Addendum No. 1

Date: September 20, 2023

Project: KCC Clubhouse

DAG Project #: 22038

P-402

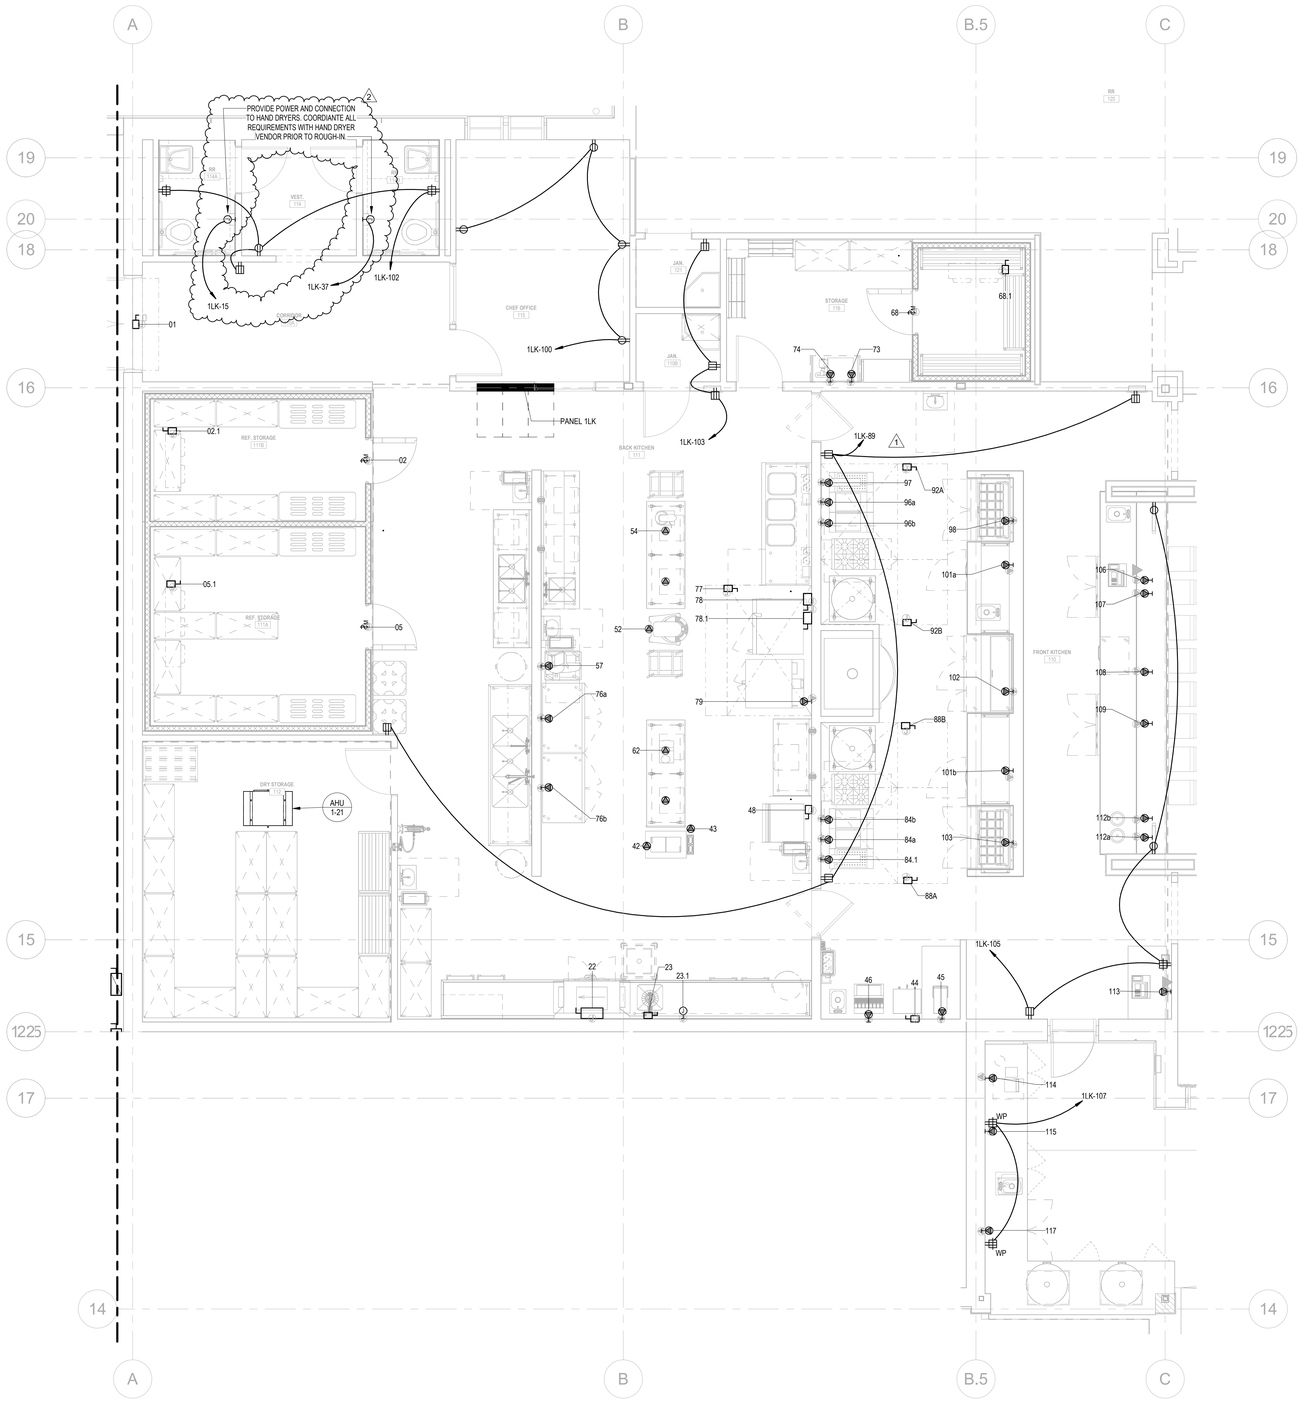
72. Sheet P-112-1
    - Hot water piping added to serve NFWH-CWHW.
73. Sheet P-112-3
    - Hot water piping added to serve NFWH-CWHW
74. Sheet P-402
    - Hot water piping added to serve NFWH-CWHW

E-101

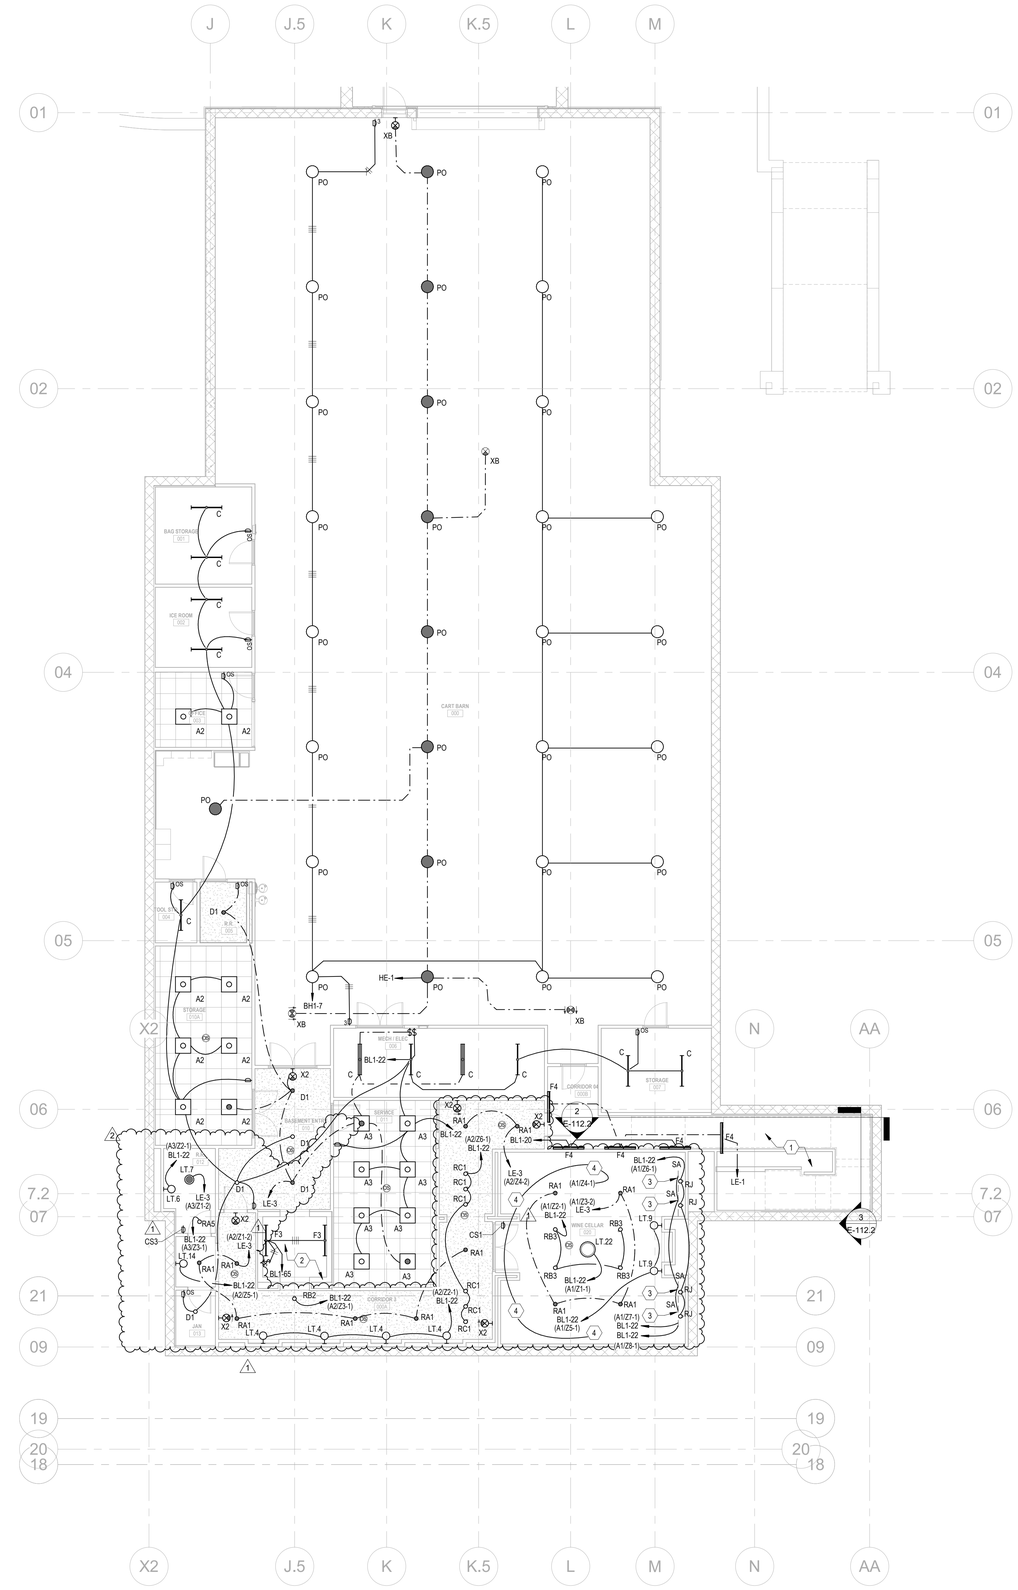
75. Sheet E-003
    - Updated light fixture schedule.
76. Sheet E-101
    - Added power for hand dryer in restroom.
    - Coordinated mechanical equipment.

E-112.1

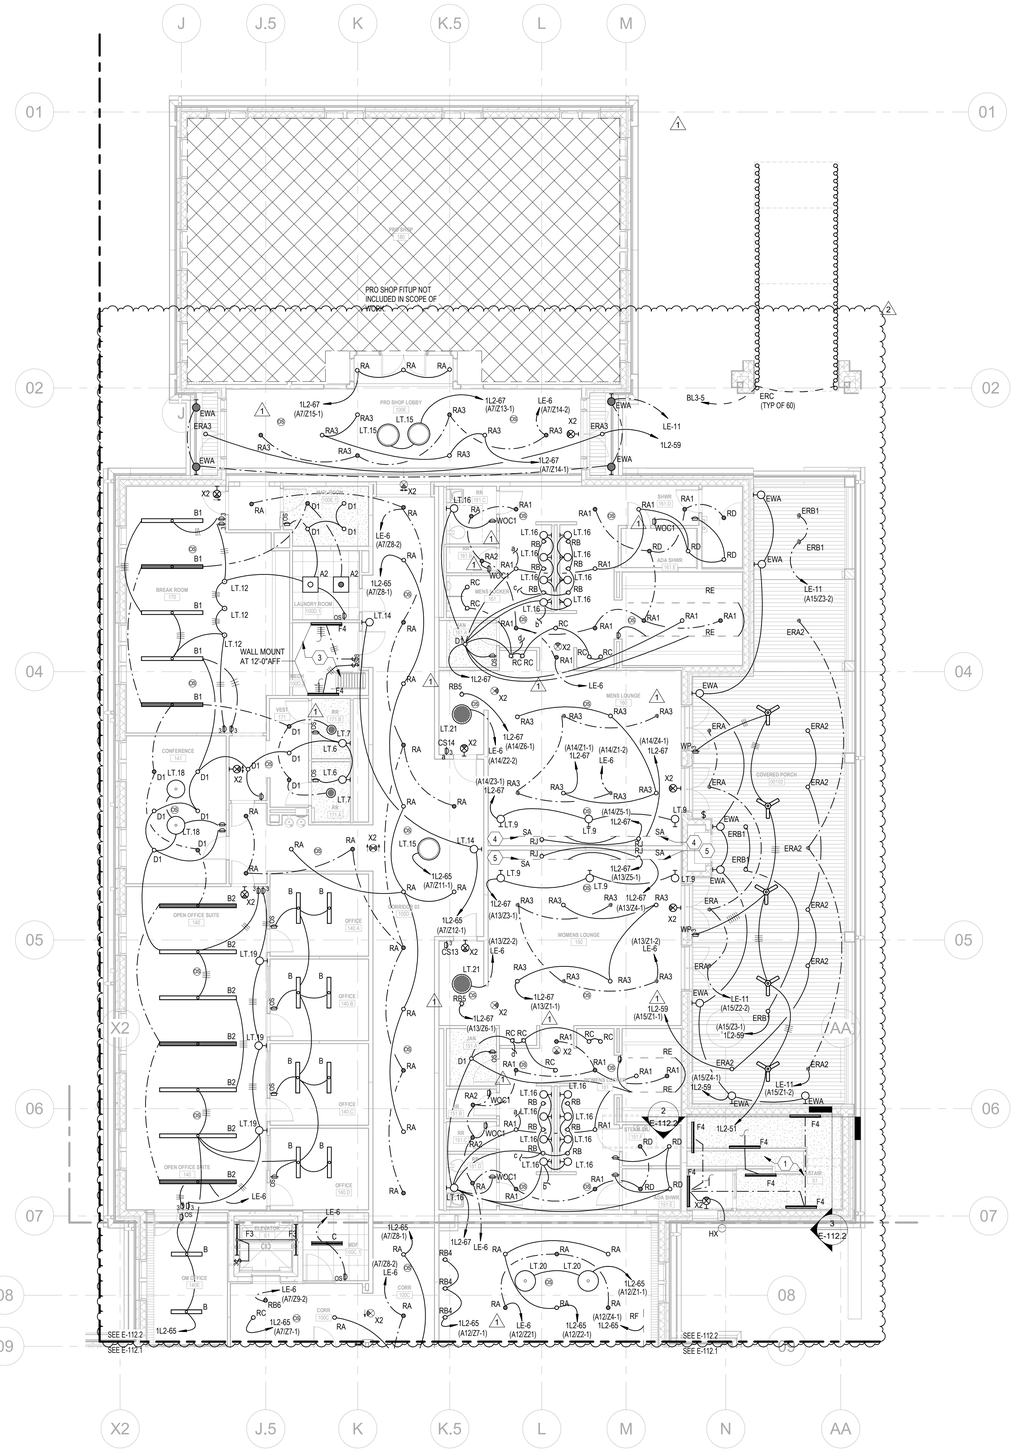
77. Sheet E-102
    - Coordinated lighting fixtures/controls with lighting control drawings.
78. Sheet E-111.1
    - Removed receptacle.
79. Sheet E-112.1
    - Coordinated lighting fixtures/controls with lighting control drawings.
